**APPLICATION FOR PERMISSION
UNDER SECTION 16 OF
THE TOWN PLANNING ORDINANCE
(CAP. 131)**

For Official Use Only 請勿填寫此欄	Application No. 申請編號	A/71-KTN/1107
	Date Received 收到日期	- 9 APR 2025

Application No. 申請編號	(For Official Use Only) (請勿填寫此欄)		
Location/address 位置／地址	Lots 1058 RP, 1059 RP, 1060 and 1061 in D.D. 107, Fung Kat Heung, Kam Tin, Yuen Long, New Territories		
Site area 地盤面積	912	sq. m 平方米	<input checked="" type="checkbox"/> About 約
	(includes Government land of 包括政府土地	N/A	sq. m 平方米 <input type="checkbox"/> About 約)
Plan 圖則	Approved Kam Tin North OZP No.: S/YL-KTN/11		
Zoning 地帶	"Agriculture" Zone		
Applied use/ development 申請用途／發展	Proposed Temporary Place of Recreation, Sports or Culture (Hobby Farm) with Ancillary Facilities and Associated Filling of Land for a Period of 5 Years

(S.16 Planning Application No. A/YL-KTN/1107)

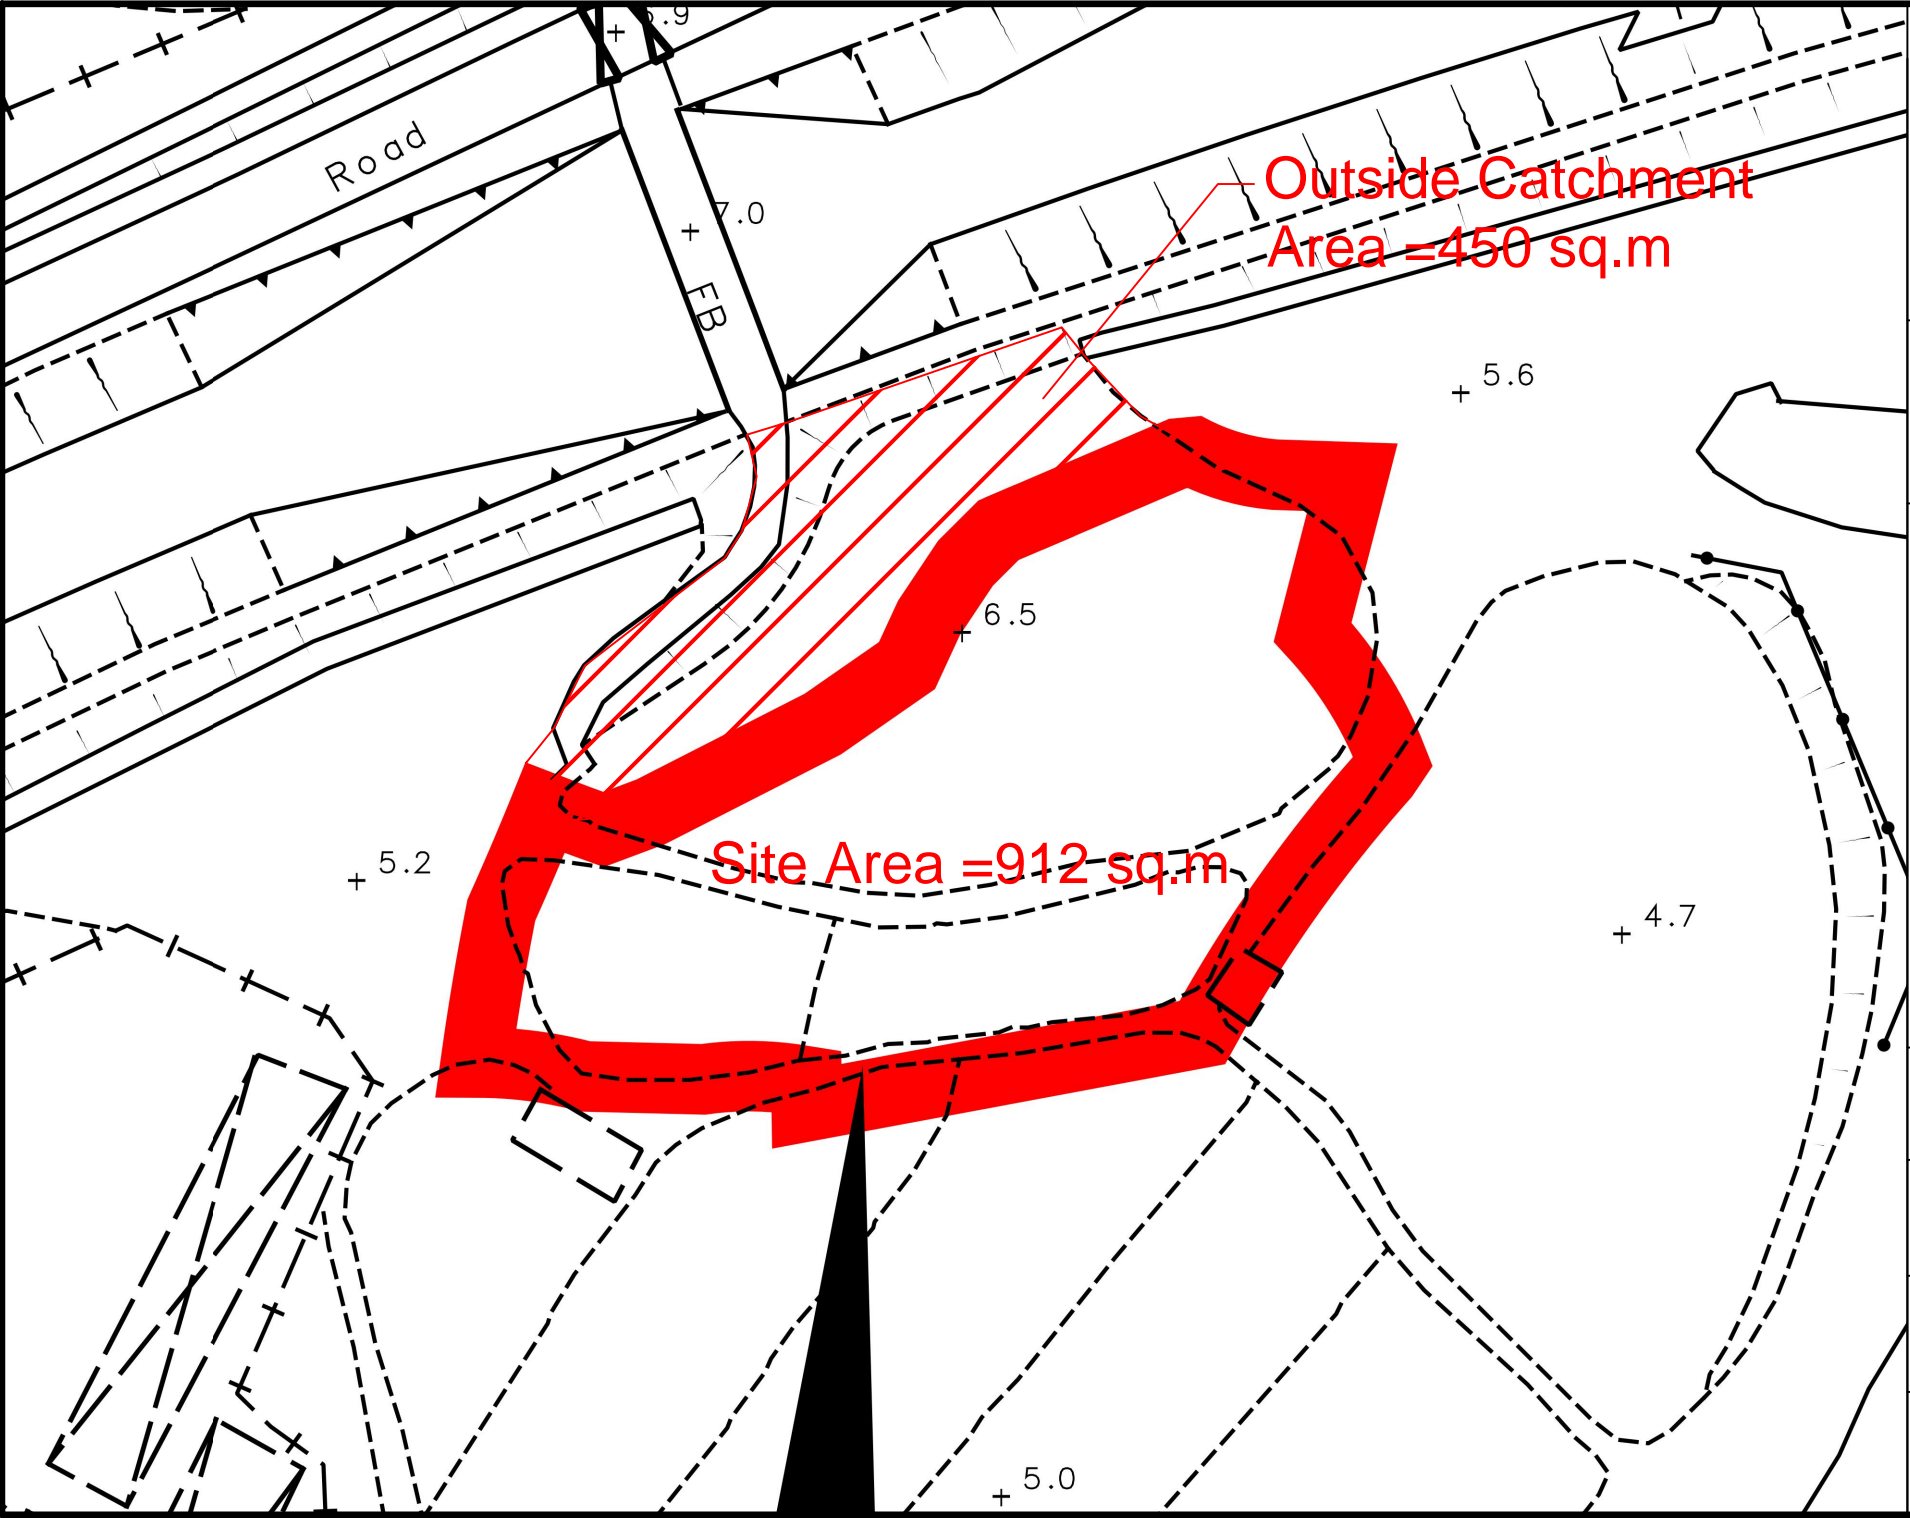
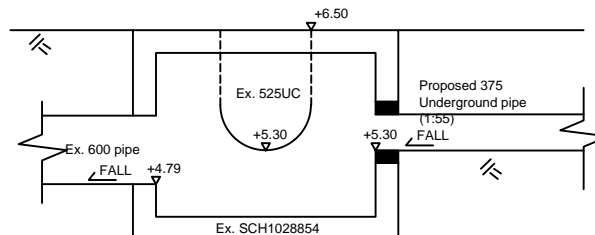
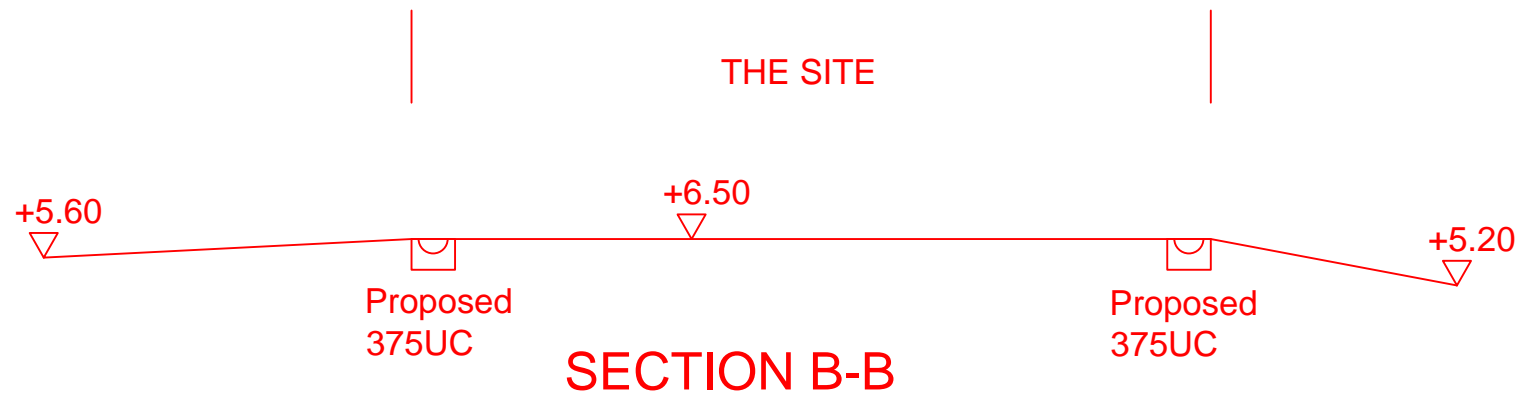
1. Comments of the Chief Engineer/Mainland North, Drainage Services Department (CE/MN, DSD)		
(a)	GEO Technical Guidance Note No. 43 should be adopted for u-channel checking as Figure 8.7 of the Geotechnical Manual for Slopes (GCO, 1984) was superseded.	TGN 43 is adopted.
(b)	Calculation – For rainfall intensity, please review the a, b and c values according to the latest SDM Corrigendum.	Table 3a, 50 years return period under corrigendum 2024 is adopted.
(c)	Please advise if any site formation/ land filling works to be carried out under this application. Please note that the overland flow from the adjacent lands should not be affected.	Minor filling will be carried out for leveling the application site to facilitate the proposed development.

- a revised drainage proposal; and
- a location plan showing a revised access.
